SUBDIVISION REVIEW SHEET

CASE NO.: C8-2023-0036.0A

SUBDIVISION NAME: Veranda Apartments

**CITY OF AUSTIN –DEVELOPMENT SERVICES DEPARTMENT
SUBDIVISION APPLICATION – MASTER COMMENT REPORT**

VERANDA APARTMENTS FINAL PLAT

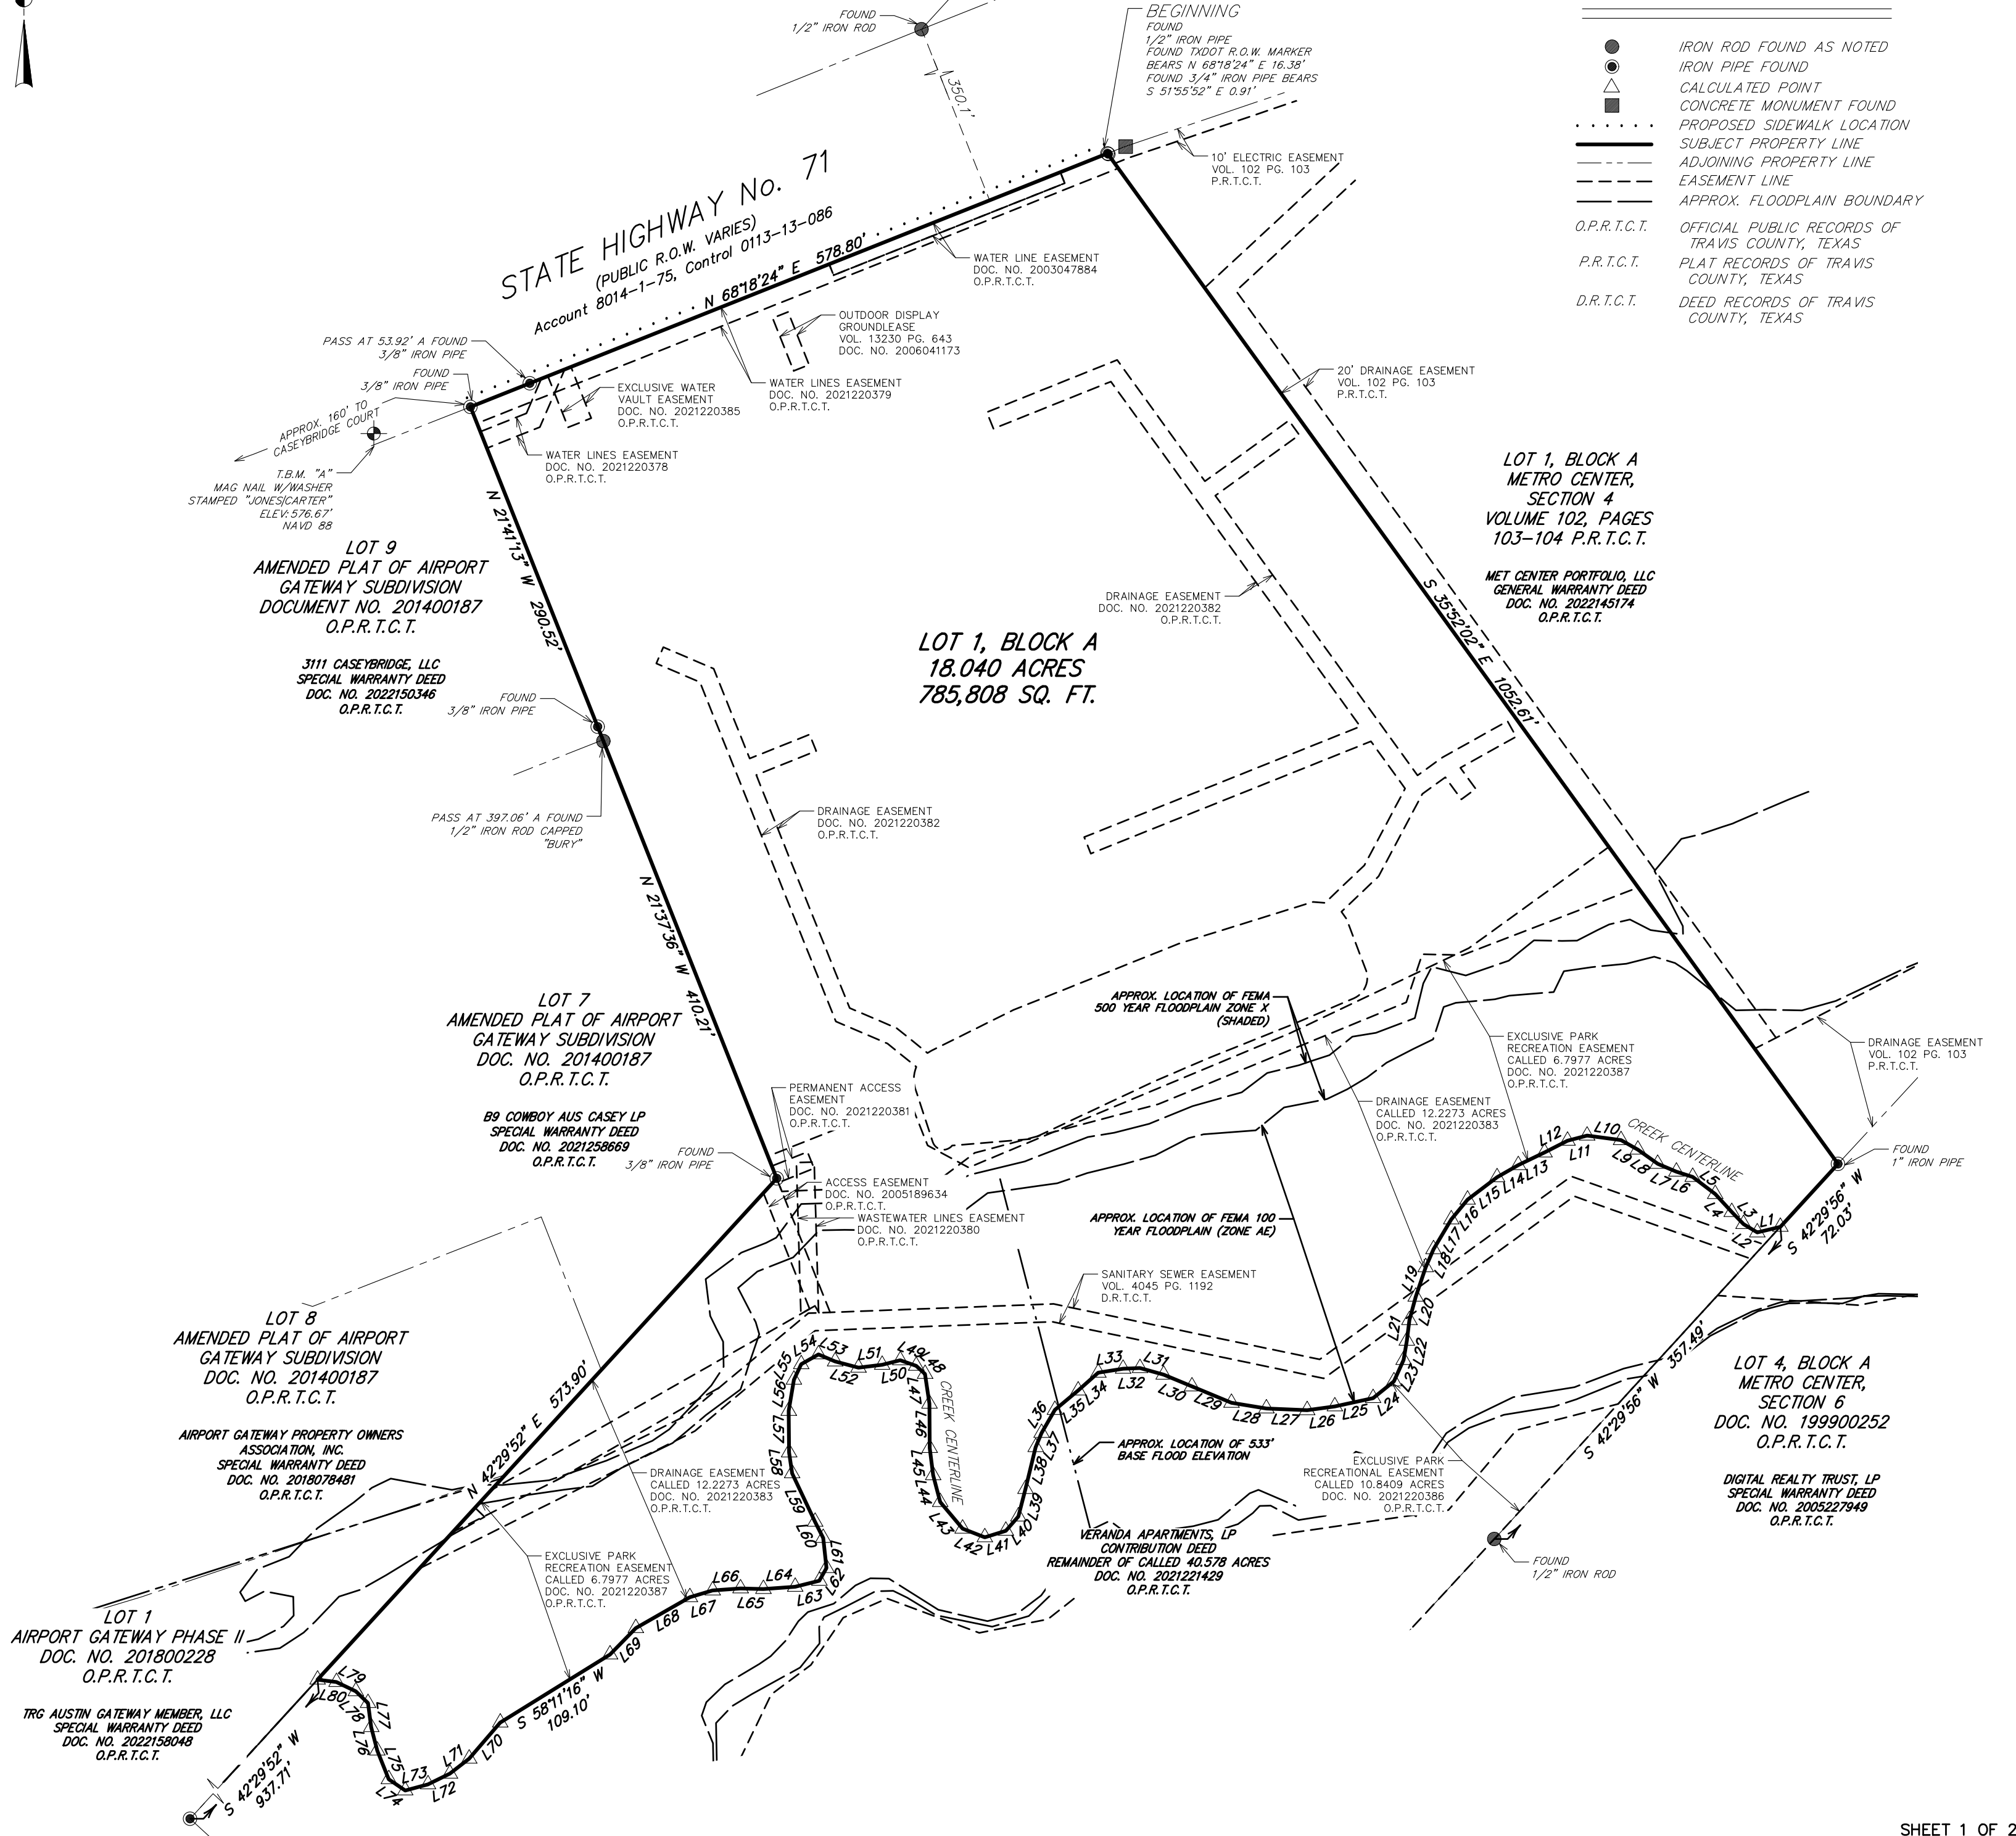
Fifteen-foot aerial electric distribution, electric telecommunications, and electric fiber easement is required adjacent to all street R.O.W. Show the easement(s) on the face of the plat.

- FP 1: As required by LDC 25-7-33 and/or LDC 30-4-33, please update the floodplain note to indicate that there are portions of the tract that are within the FEMA 100-year floodplain. Update the FIRM panel number and effective date to the most current map.

- FP 2: Please verify that the drainage easement shown on the plat encompasses the limits of the FEMA and City of Austin Regulatory floodplain within a drainage easement per LDC 25-7-152 and/or LDC 30-4-152.

SR 2. Add Case # **C8-2023-0036.0A** in the bottom right hand corner of each sheet. 25-1-83

SR 4. Indicate scale of the plan/plat next to the north arrow. 25-1-83

SR 7. Revise the lines as follows: 25-1-83

- a. The boundary line must be solid and the heaviest weighted line. Verify the boundary line accurately encompasses only the area inside the preliminary plan.
- b. All proposed lot lines must be solid and the second heaviest line.
- c. Easement lines (existing and proposed) must be broken, and a lighter weight than lot lines. The easement area may be shaded or hatched.
- d. Lot lines outside but adjacent to the project must be broken and the lightest weight.

SR 17. Remove Plat Notes #11, #15, #18, #19, #20, #22, #23, unless specifically requested by a City of Austin reviewer. 25-1-83.

W. S.E.R. Name: 7135 E Ben White Multifamily
W. S.E.R. Number: 4762

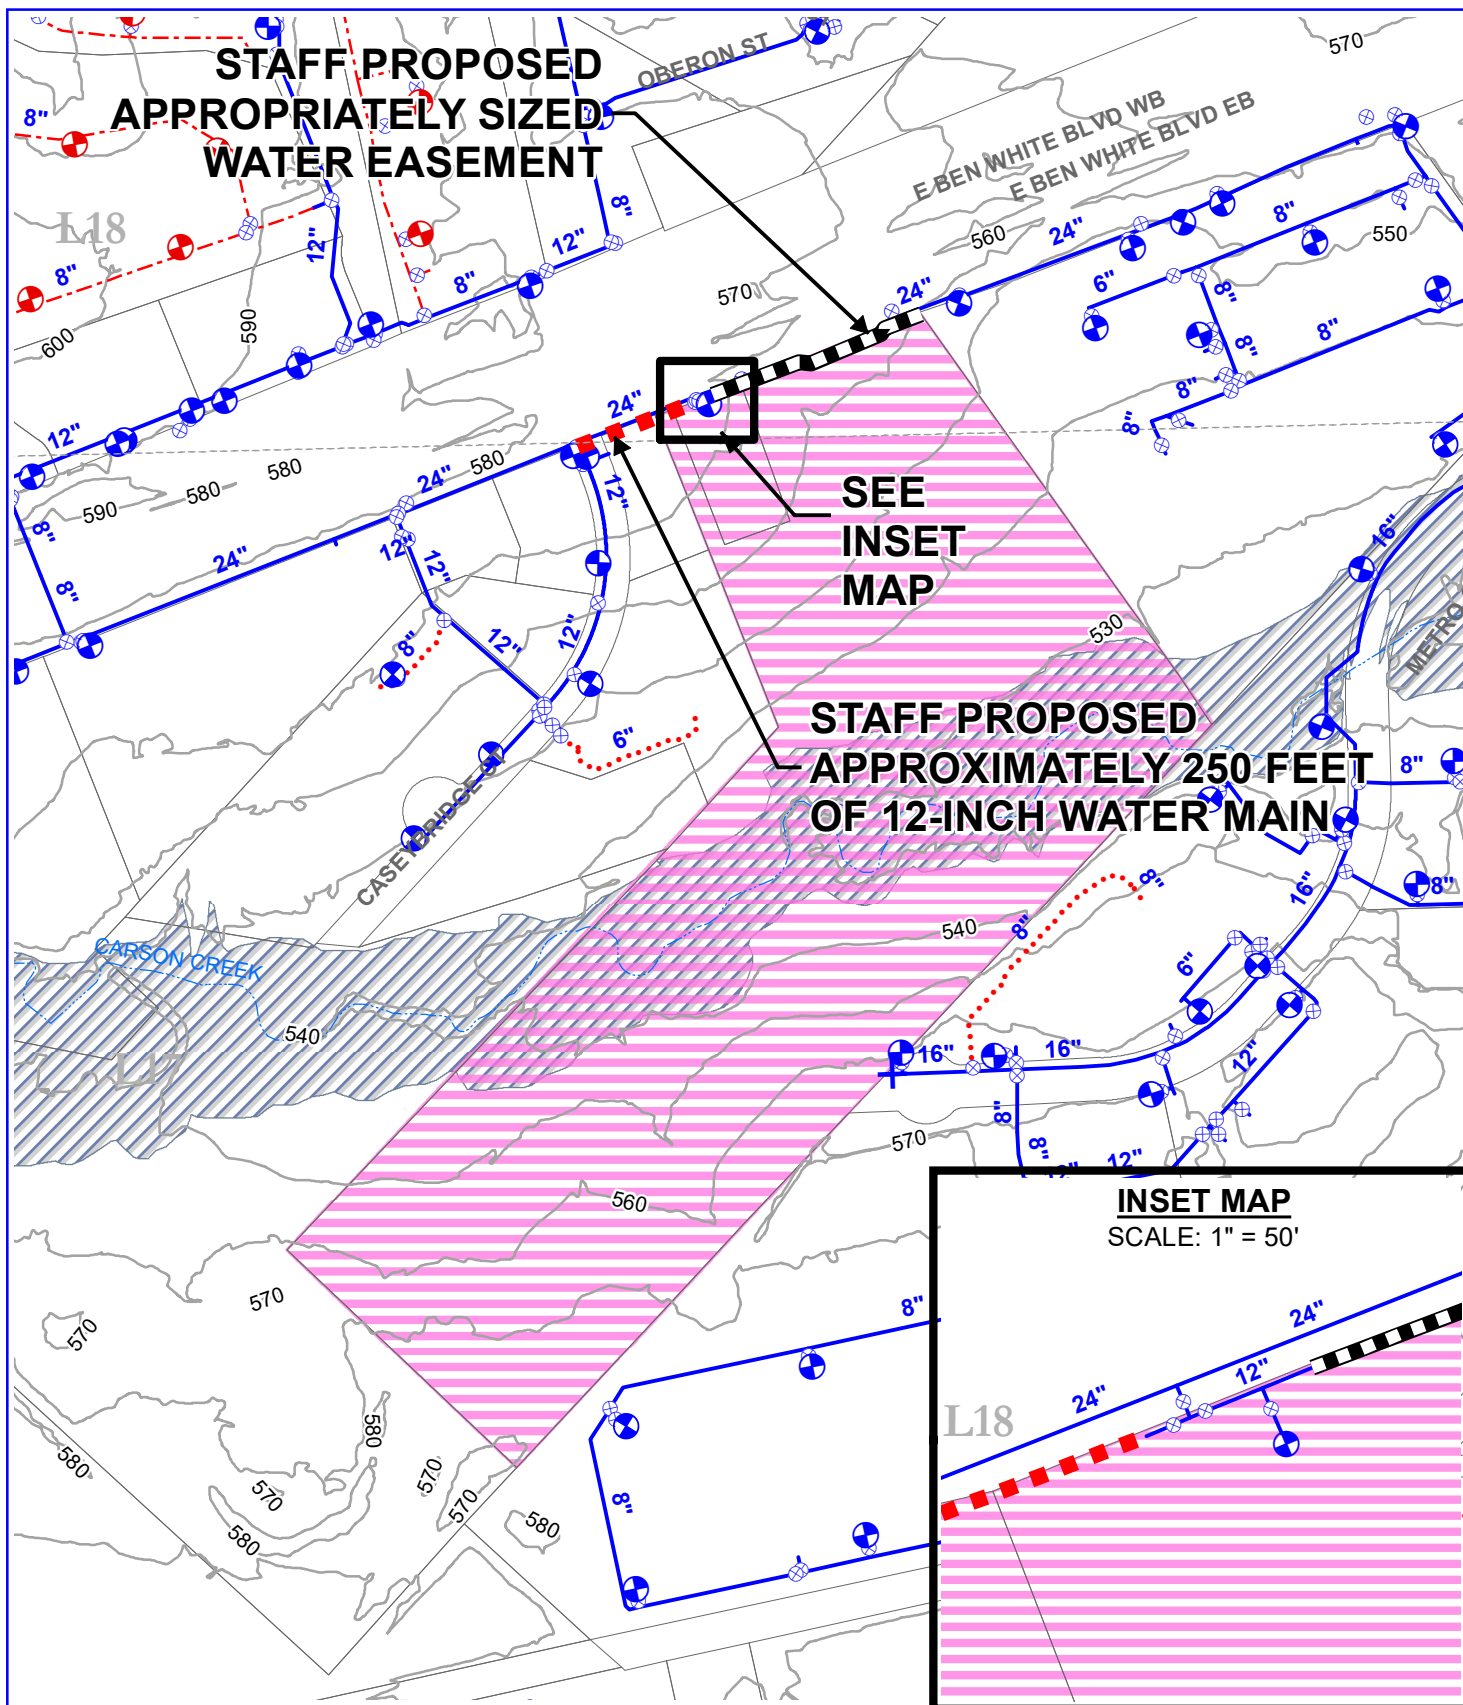
Applicant shall construct approximately 250 feet of 12-inch water main from the existing 12-inch water main (Project No. 2002-0019) located north of the subject tract and extend southwest along E Ben White Blvd EB to the existing 12-inch water main (Project No. 2014-0786) in Caseybridge Ct located west of the subject tract, as approximately shown on the attached map.

Applicant shall also dedicate an appropriately sized water easement to the City of Austin from the existing 12-inch water main (Project No. 2002-0019) located north of the subject tract along E Ben White Blvd EB to the eastern boundary of the subject tract, as shown on the attached map.

W.W. S.E.R. Name: 7135 E Ben White Multifamily
W.W. S.E.R. Number: 4763

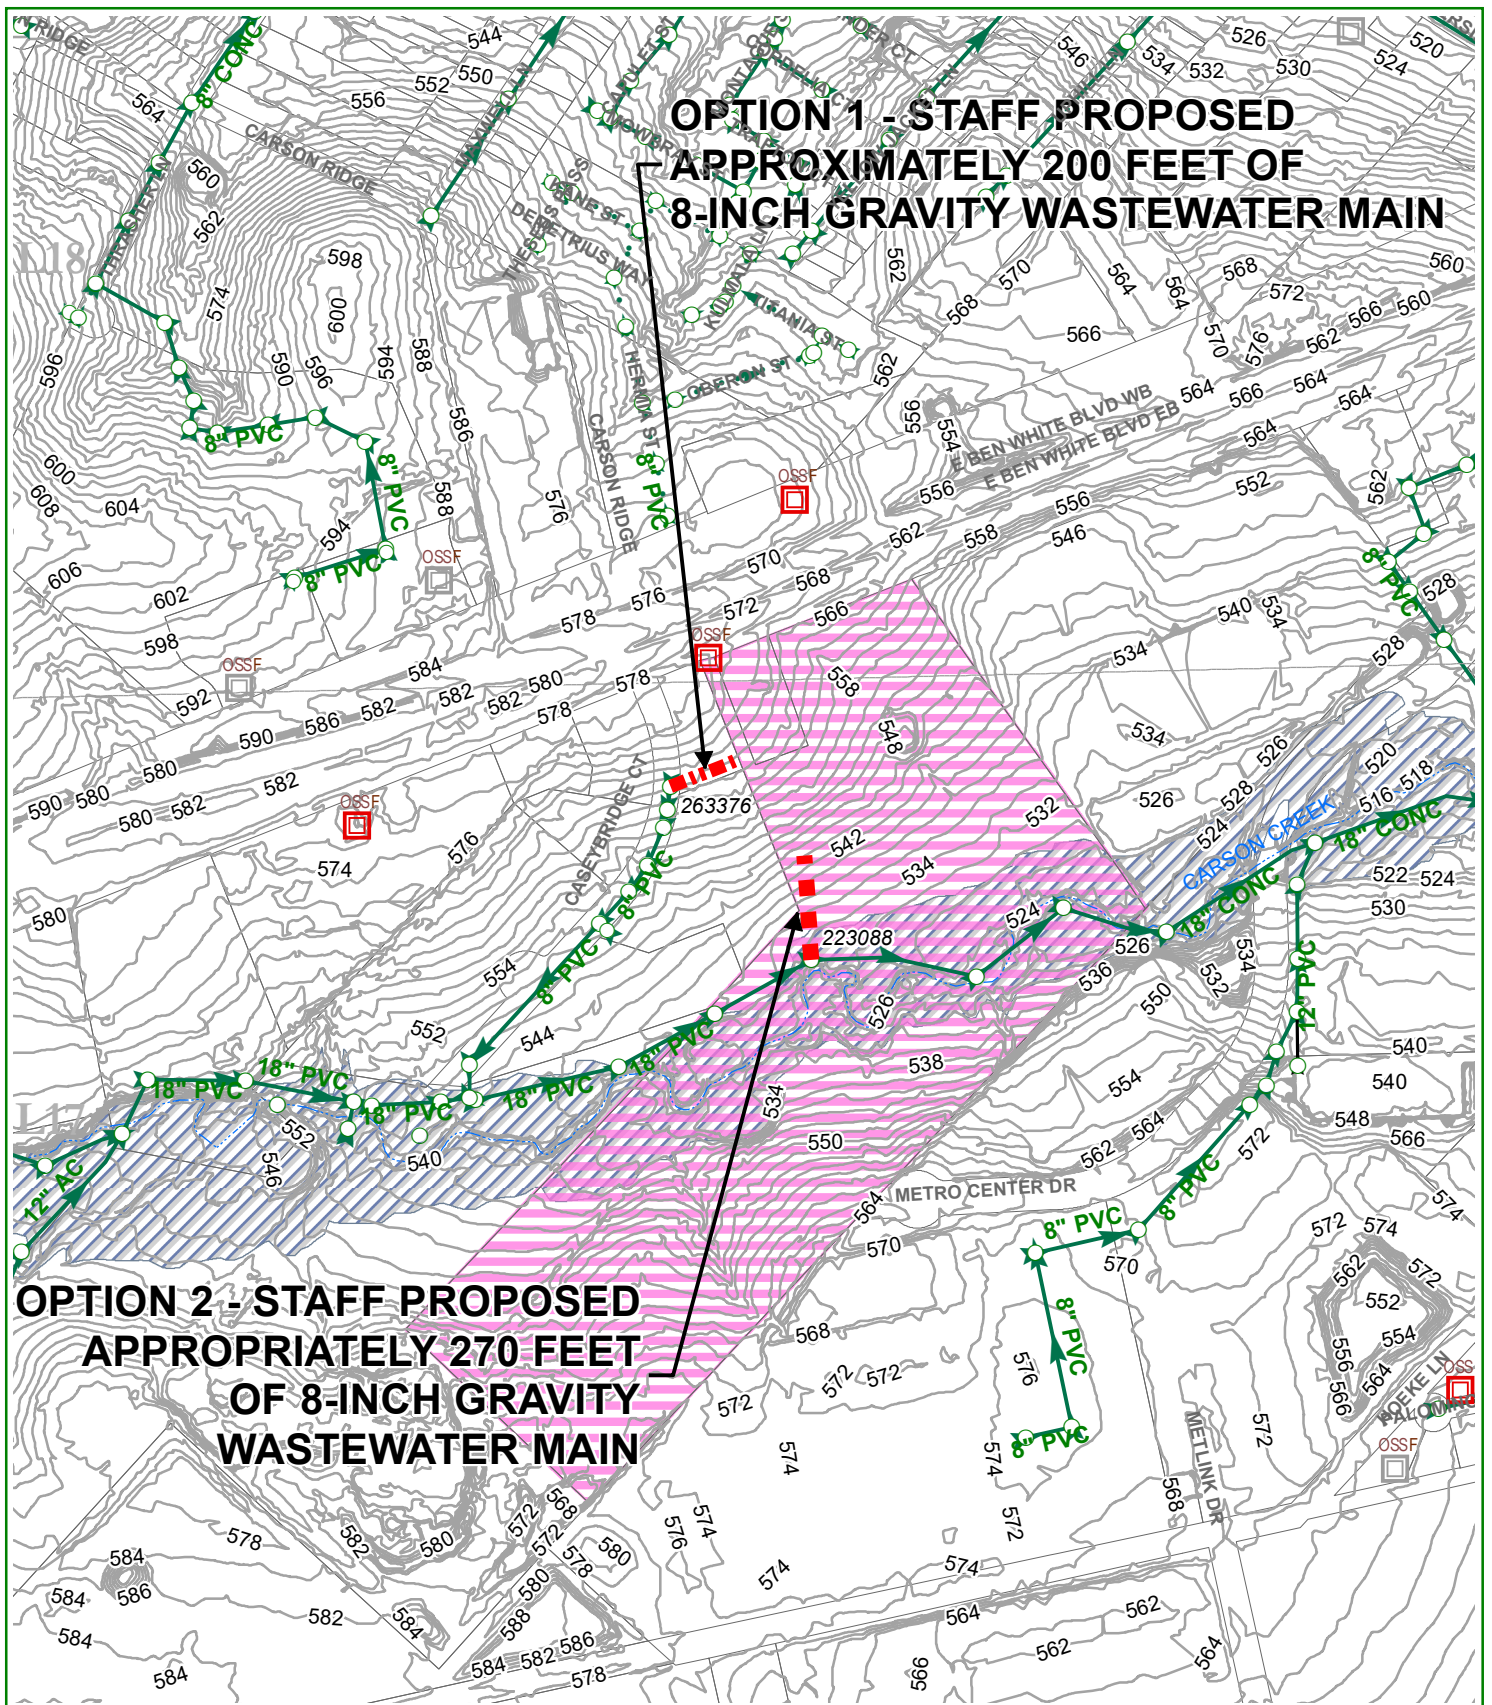
Applicant shall construct approximately 200 feet of 8-inch gravity wastewater main from the existing 8-inch gravity wastewater main (Project No. 2014-0786: MH ID# 263376) in Caseybridge Ct and extend northeast to the subject tract, as approximately shown on the attached map.

Applicant shall construct approximately 270 feet of 8-inch gravity wastewater main from the existing 18-inch wastewater interceptor (Project No. 71-0133; MH ID# 223088) located on the north side of Carson Creek and extend north within the subject tract to a point located outside the 100-year FEMA floodplain and the Critical Water Quality Zone (CWQZ), as approximately shown on the attached map.

Applicant shall install a manhole at the end of the proposed 8-inch gravity wastewater main described above. This manhole may be used in the future for odor control measures, if needed.
